# Product Change Notification

**Change Notification #:** 119640-00

**Change Title:** Intel® Ethernet SFP28 SR Optic,  
PCN 119640-00, Product Design, Label,  
Manufacturing Site,  
Update to External Housing and Adding Supplier

**Date of Publication:** August 03, 2023

### a. Latch Change

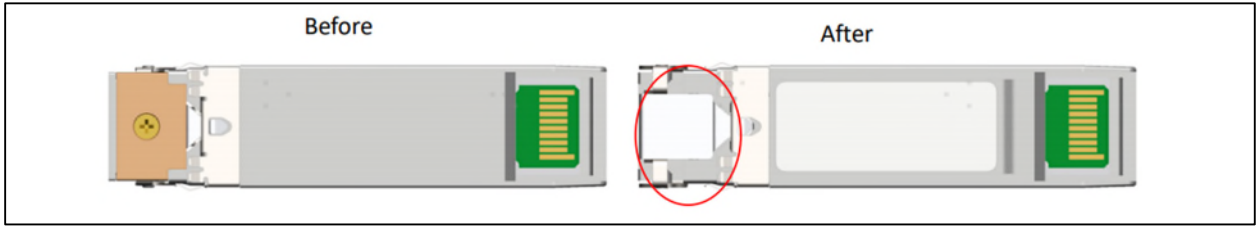
1. The original supplier is adding a manufacturing site in Thailand resulting in a change to the manufacturer's part number. The new MFG P/N that will be printed on the label is LTF8505-BE-IN1. The parts manufactured at the new site will also incorporate an updated external optical housing latch to improve locking and unlocking, removal of the bottom side cover and screw and an increased bottom side label groove for label placement.

c. Label groove increased

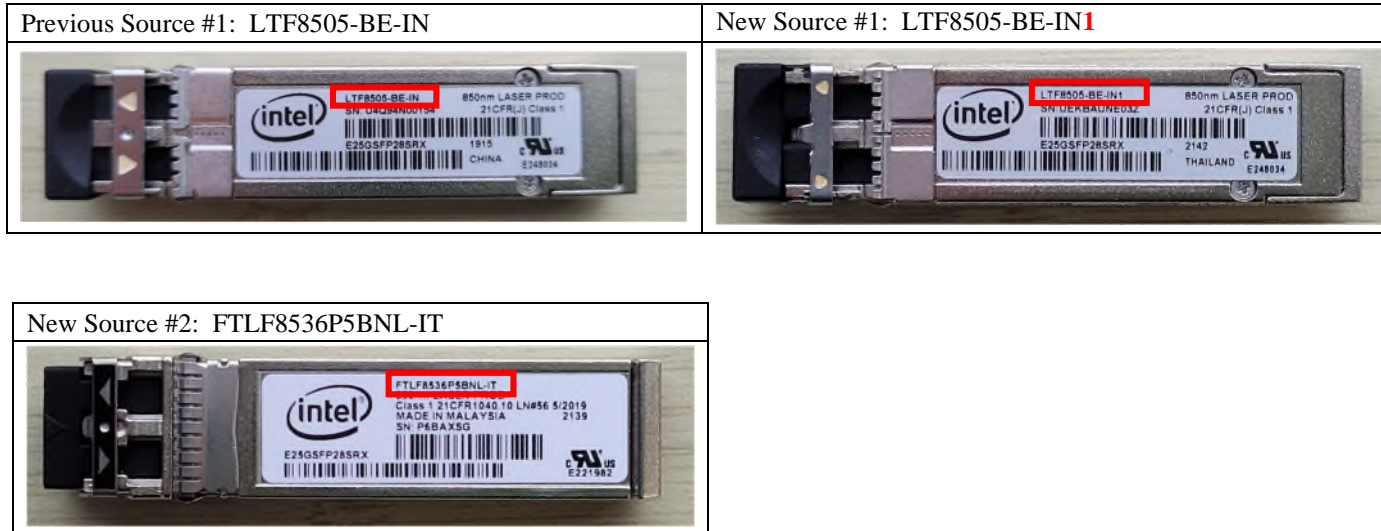
2. Intel has also qualified a 2nd source in Malaysia. The MFG P/N printed on the label from this source will be FTLF8536P5BNL-IT.
